UNITED STATES PATENT AND TRADEMARK OFFICE

APPLICATION NO.	FILING DATE	FIRST NAMED INVENTOR	ATTORNEY DOCKET NO.	CONFIRMATION NO.
09/899,530	07/06/2001	Toshiya Kojima	Q64665	3383

Office Action Summary

DETAILED ACTION***Claim Rejections - 35 USC § 102***

FIG.16

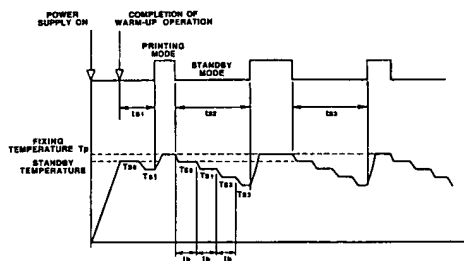
- {claim 1} An image-forming device (column 1, lines 8-12) comprising: a heating device (column 1, lines 29-30); a control device which controls the heating device by on/off control (column 1, lines 29-47), and alters a period of on/off control in accordance with control modes (figure 16, reference Printing Mode, Standby Mode, ts1, ts2, ts3), the control modes including a printing mode for maintaining the heating drum at the predetermined temperature during image-formation (figure 16, reference printing mode; column 1, lines 31-38), and at least one ordinary mode which is used at times other than during image formation (figure 16, reference standby mode; column 1, lines 31-38), wherein, if a period of on/off control of the printing mode is T1 and a period of on/off control is T0, then $T1 < T0$ (figure 16, reference Printing Mode, Standby Mode, ts2)

- {claim 2} standby mode (column 1, lines 31-38); pre-heating mode (figure 16, reference Ts1, Ts2, Ts3; column 1, lines 57-60; column 2, lines 7-10) ; if the period of on/off control of the printing mode is T1, a period of on/off control of the standby mode is T2 and a period of on/off control of the pre-heating mode is T3, then at least one of the

following relationships: $T1 < T2$ and $T1 < T3$ is satisfied ($T1 < T3$; figure 16, reference Ts1, Ts2, Ts3)

- {claim 7} when image formation has finished, the printing mode is deselected and the standby mode is selected (figure 16, reference Printing Mode, Standby Mode)

- {claim 8} if the standby mode is selected and no image-formation is performed for a predetermined period of time, then the pre-heating mode is selected (figure 16, reference Ts0, Ts1)

- {claim 9} in the pre-heating mode, the heating drum is maintained at a temperature lower than the predetermined temperature (figure 16, reference Ts0, Ts1)

FIG.1

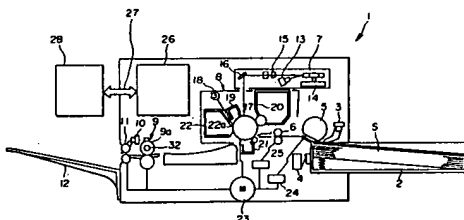
- {claim 4} information of the image is recorded onto a photosensitive material by exposure (figure 1, reference 18; column 4, lines 67-68), and the image is formed on a transfer material which is superposed with the photosensitive material at the heating drum (column 1, lines 14-22). As drafted, this reads on the claimed invention.
